**ITEM E7 - Lobdell Subdivision**

KPB File # 2022-018

## Lobdell Subdivision

STAFF REPORT

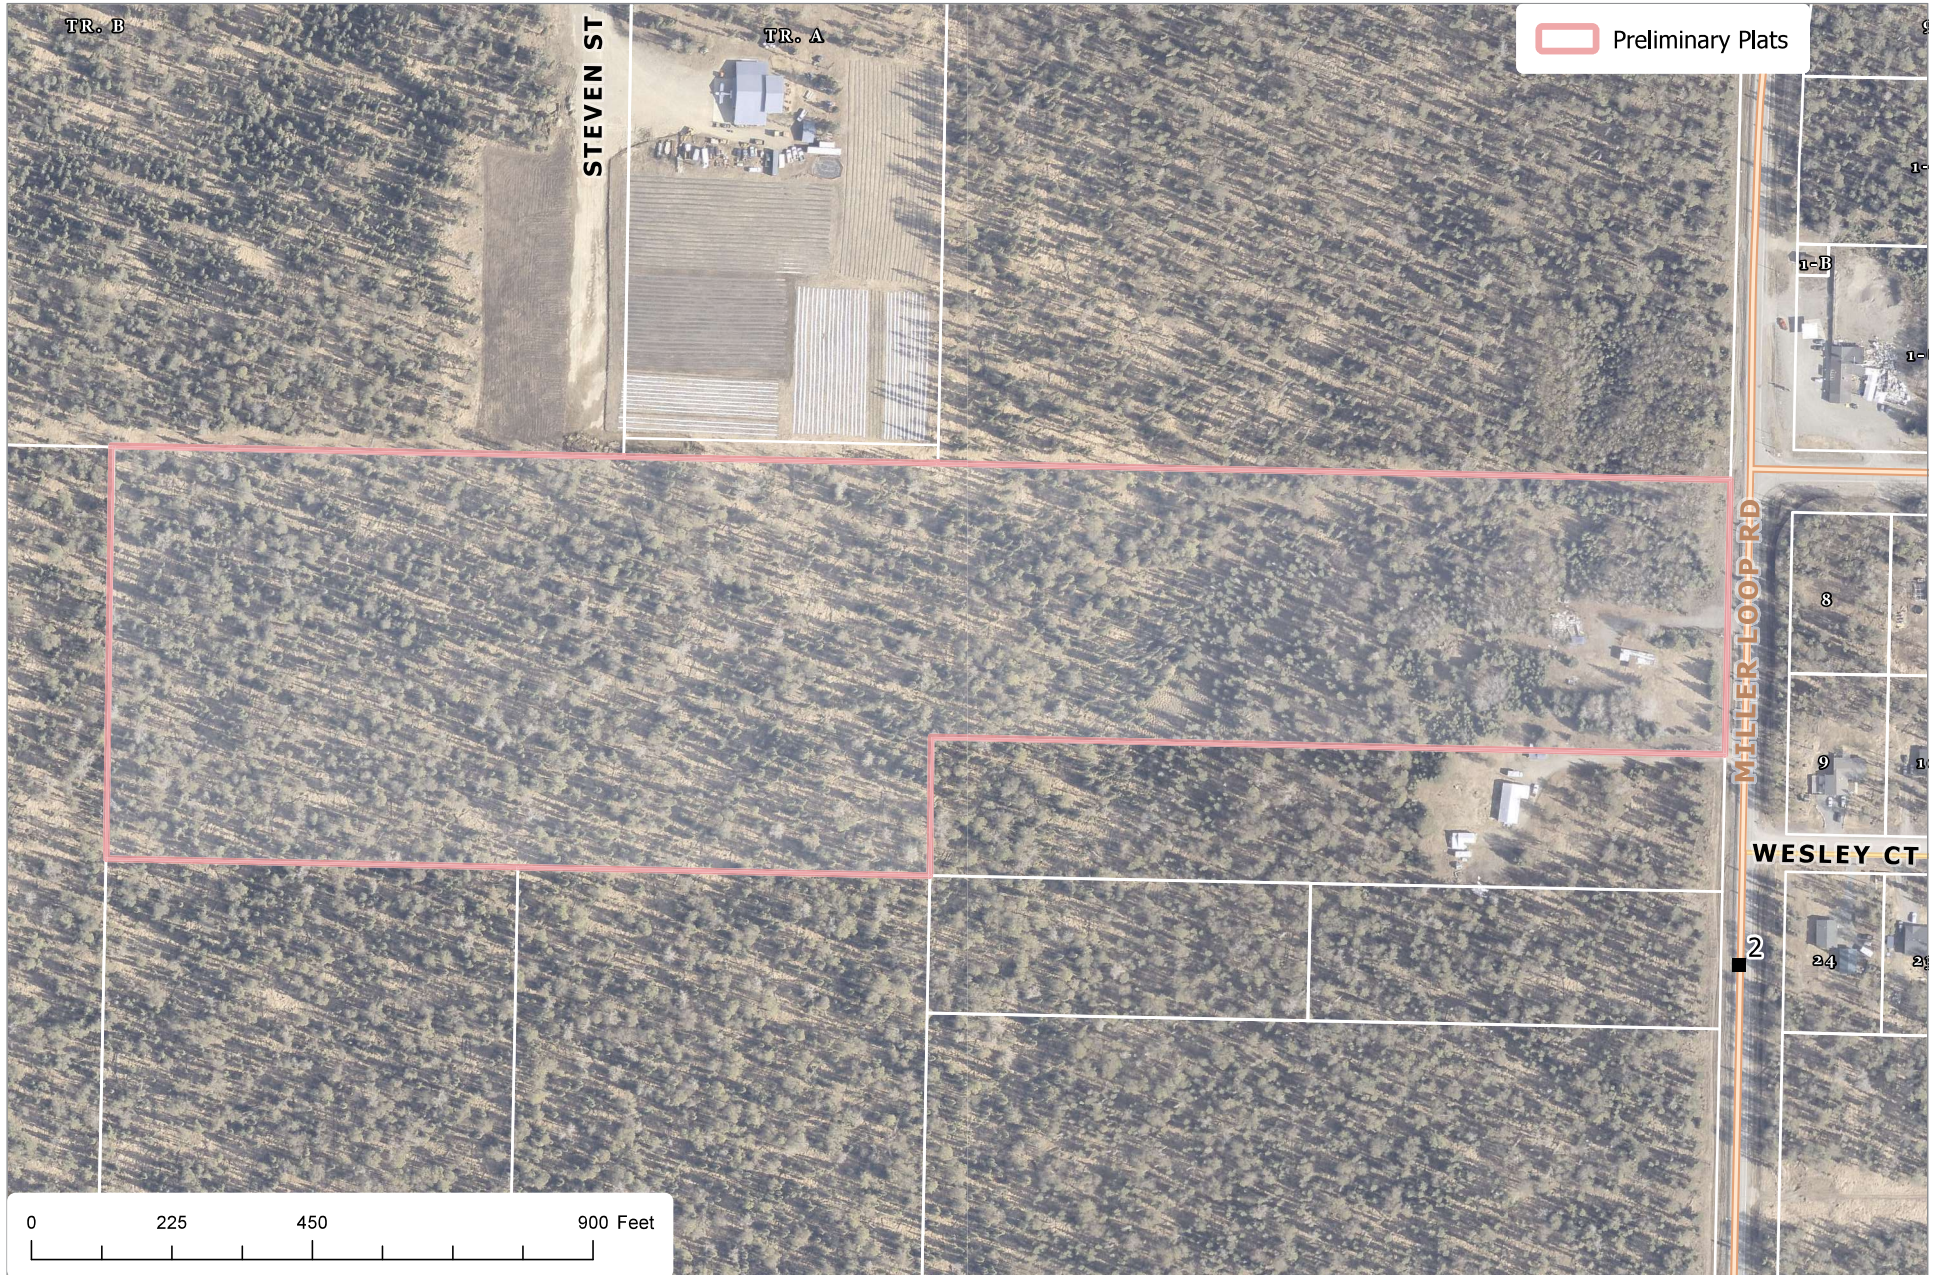
This plat is proposing to dedicate the 50 foot portion of Miller Loop Road along the eastern boundary. The plat will also dedicate a 30 foot wide right of way along the northern length of the subdivision as Robert Walker Avenue. This will bring the smaller section already dedicated into compliance. The 33 foot section line easement coincides with that dedication is shown and labeled on the plat as well as the easement north of the section line. **Staff recommends the 33 foot section line easement south of the Miller Loop Road dedication be depicted and labeled.**

Per KPB Assessing records, a mobile home is present on the parent parcel. It appears the structure will be within proposed Tract B. A driveway already exists to Miller Loop Road. Using KPB GIS Imagery and the dimensions provided by the surveyor, the driveway might be on Tract A or very close to the lot line. ***Staff recommends the surveyor verify that the current lot design proposed will not create an encroachment. A driveway easement may be required if ownership of the lots changes and the driveway is not completely contained within Tract B. Any encroachments found during the field survey shall be disclosed with the submittal of the final and may require additional plat notes or methods of resolution presented.***

Tract B does not comply with the 3:1 requirement and an exception has been requested.

Lobdell Street is proposed to be 60 feet wide and provide additional access to Tract C and Tract D as well as the two parcels to the south. Staff generally recommends a t-type turnaround be provided at the end of dedication as proposed for Lobdell Street. This will provide the continuation of right of way and provide adequate turn around area. The dedication is proposed as a full 60 feet width, and the roads department did not request additional right of way and a comment was not received by emergency services. There are no east-west dedications in the area

**Utility Easements** There are no platted utility easements for the lots within the preliminary plat. The Certificate to Plat does not indicate any easements have been granted by document. Plat note 6 will be granting the required 10 foot utility easements along the dedicated right of ways. **Staff recommends** depict the utility easements if possible.

*Verify the size used for the monuments on the face of the plat. The size should be similar to those within the legend. Label the Basis of Bearing on the final plat.*

- G. The status of adjacent lands within 100 feet of the proposed subdivision boundary or the land status across from any dedicated rights-of-way that adjoin the propose subdivision boundary, including names of subdivisions, lot lines, block numbers, lot numbers, rights-of-way; or an indication that the adjacent land is not subdivided;  
**Staff recommendation:** Lot 1C, located north of Holt Lamplight Road, should include a block designation of Block 3.

**Staff recommendation:** *An acceptance for the borough is present. Miller Loop Road is a state right of way. Miller Loop Road should be removed from the Borough's acceptance. An additional acceptance for Miller Loop Road should be added to the plat to be signed by a state official. The surveyor should work with Alaska DOT to verify the status of Miller Loop Road and to determine the official to sign the plat.*

**Staff recommendation:** *Update plat note 1 by adding a space between "Subdivision" and "Paragon". Add a plat note for any exceptions granted.*

**Staff recommendation:** *Mr. Lobdell's title should have his title of trustee added behind his name. Staff will require additional documentation to verify that Mr. Lobdell is currently able to sign on behalf of the trust. Comply with 20.60.190.*

Staff Discussion: KPB Code states that the average depth of a lot shall be no greater than three times the average width. The design of Tract B creates a ratio of 6.2:1.

**Staff recommends the plat committee concur that an exception for block length is not required as the plat is improving the block and large acreage lots can improve the block when further subdivided.**

for future plats of this subdivision to connect. **Staff recommends** the plat committee concur a turnaround area is not required at this time in order to not limit future right of way extensions unless requested by emergency responders or the roads department.

Staff reviewed the exception request and recommends granting approval.
